RE: Annual Inspection for Parcel AP  
North Ridge Estates Superfund Site  
ECSI No. 5998

2023 Annual Inspection Summary Report  
North Ridge Estates - Operable Unit 1  
Klamath Falls, Oregon

Figure  
AP.3

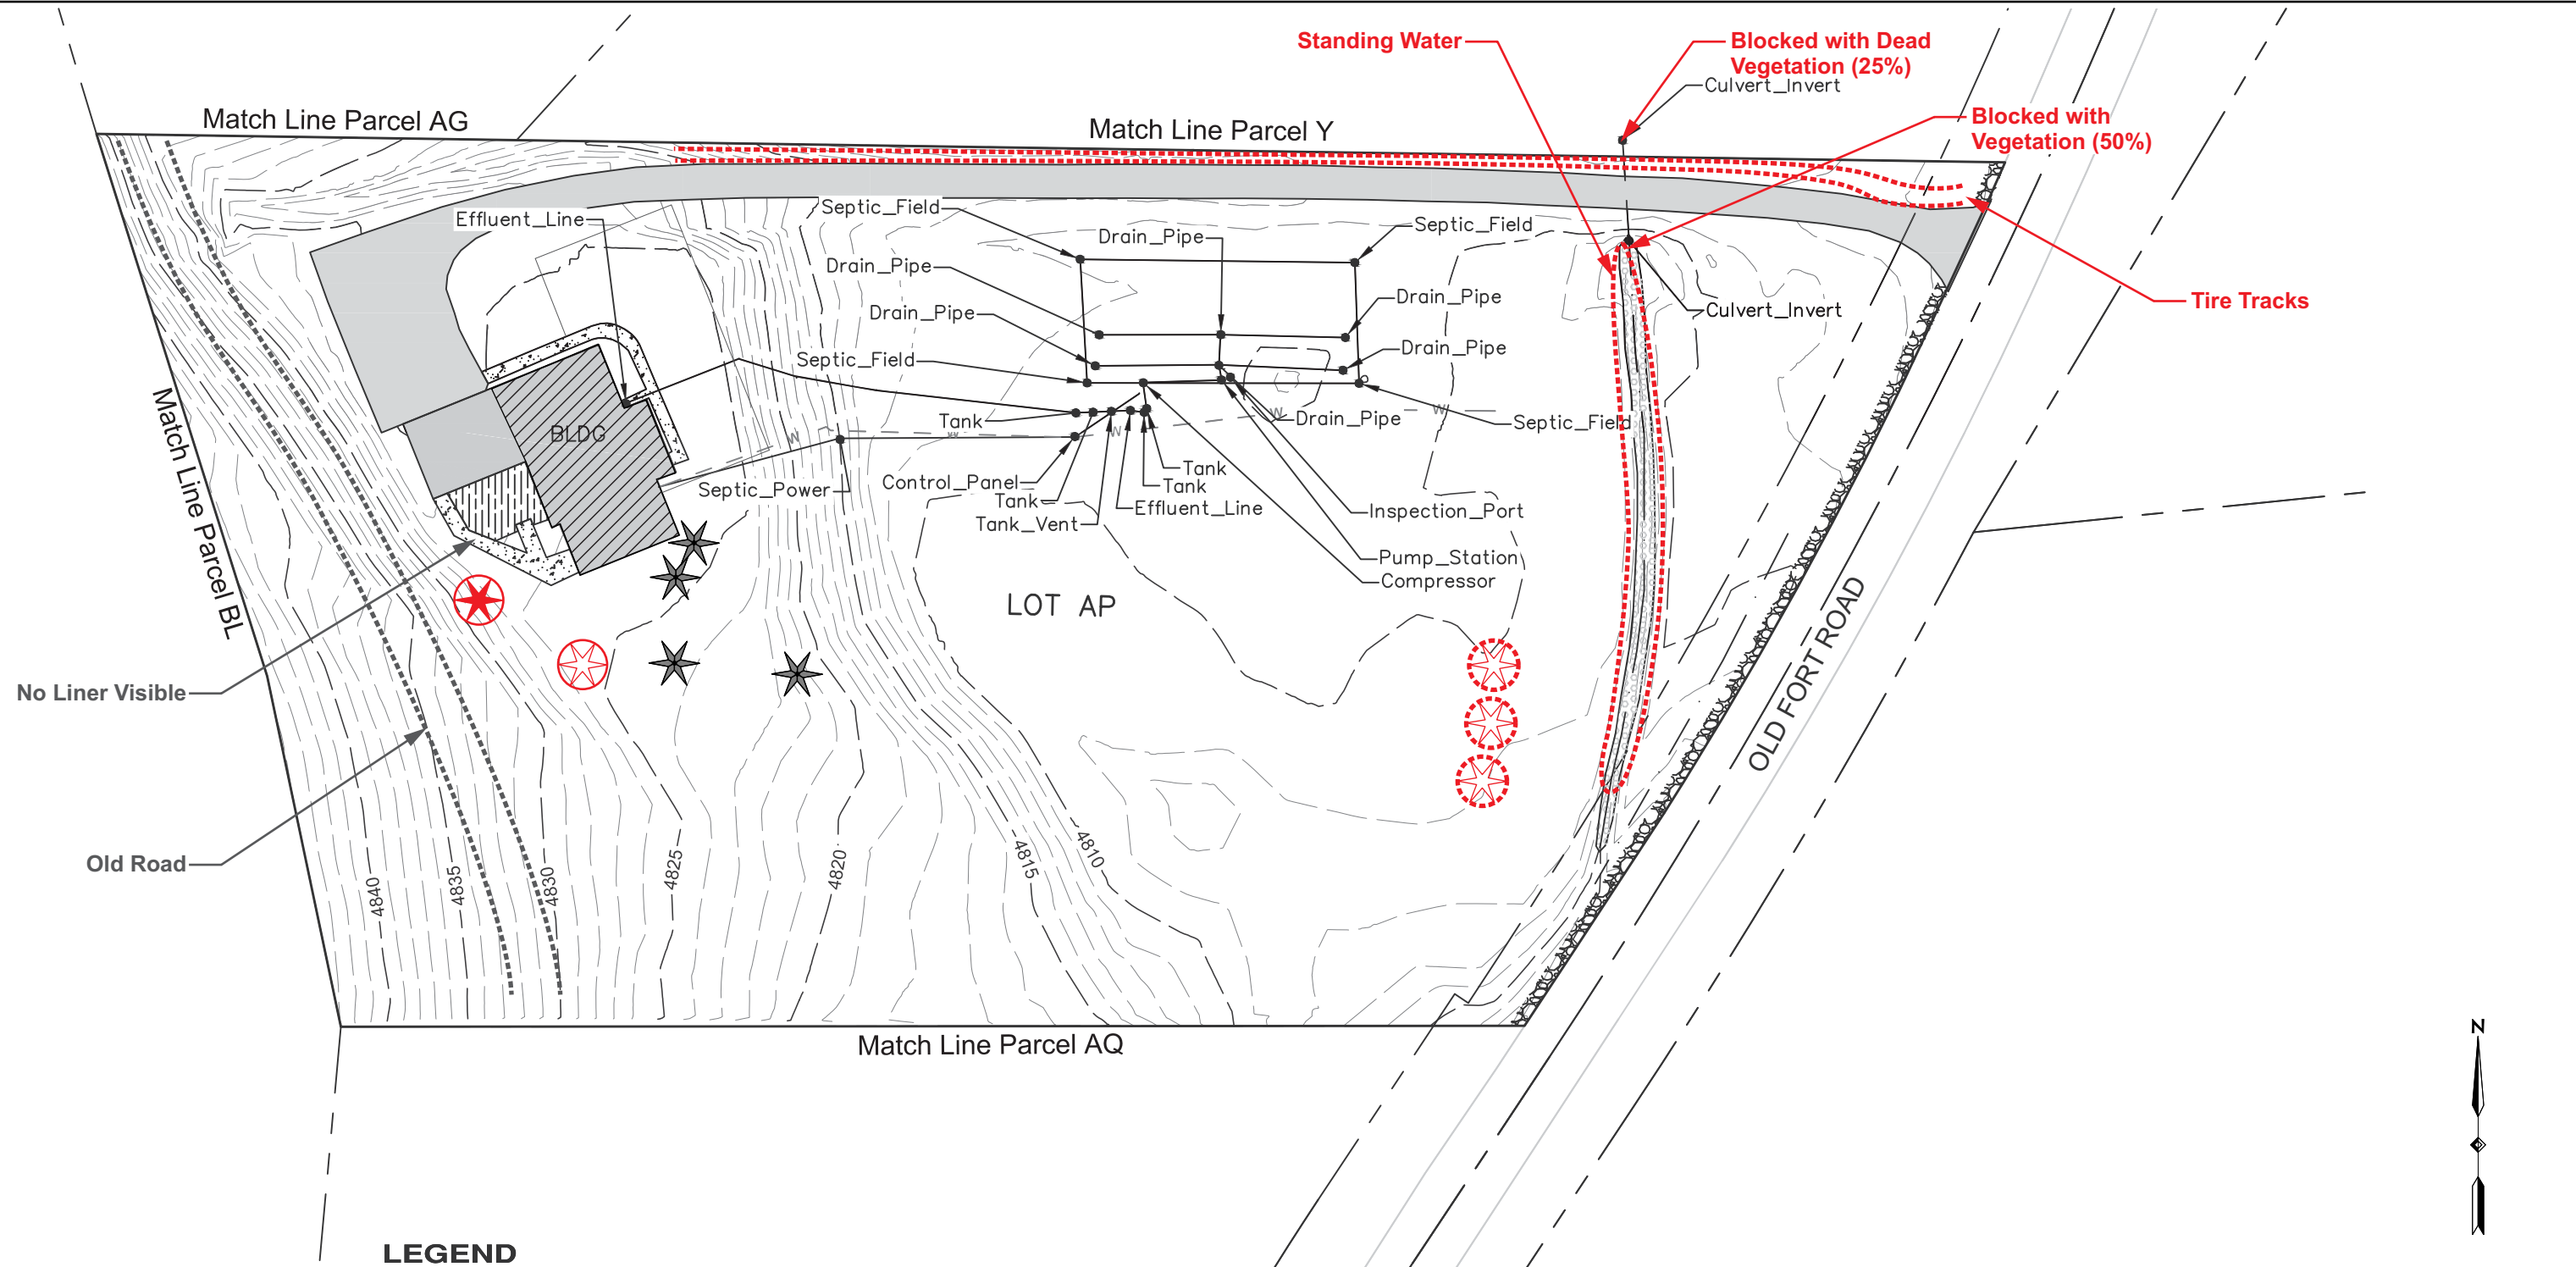
1. **Blocked culvert.** The end of the culvert located below your driveway remains partially obstructed (see enclosed figure).

Ditches and Culverts	Obstructions observed in ditches or culverts that may impede conveyance of stormwater?	<input checked="" type="checkbox"/>	<input type="checkbox"/>	<input type="checkbox"/>	<input type="checkbox"/>	Culverts near the northeast area of parcel were observed to be obstructed; standing water observed near culverts.	Remove vegetation obstructing culverts to enable stormwater flow.
	Damaged observed to riprap surface? Note if riprap is not intact or not effectively providing armor protection.	<input type="checkbox"/>	<input type="checkbox"/>	<input checked="" type="checkbox"/>	<input type="checkbox"/>		
	Are there any areas that show signs of excessive scour? (i.e., gullies forming along centerline of ditch)	<input type="checkbox"/>	<input type="checkbox"/>	<input checked="" type="checkbox"/>	<input type="checkbox"/>		
	Are culvert inlets and outlets damaged?	<input type="checkbox"/>	<input type="checkbox"/>	<input checked="" type="checkbox"/>	<input type="checkbox"/>

**Corrective Action.** Remove the material obstructing the culvert to allow the unrestricted flow of stormwater by November 12, 2023.
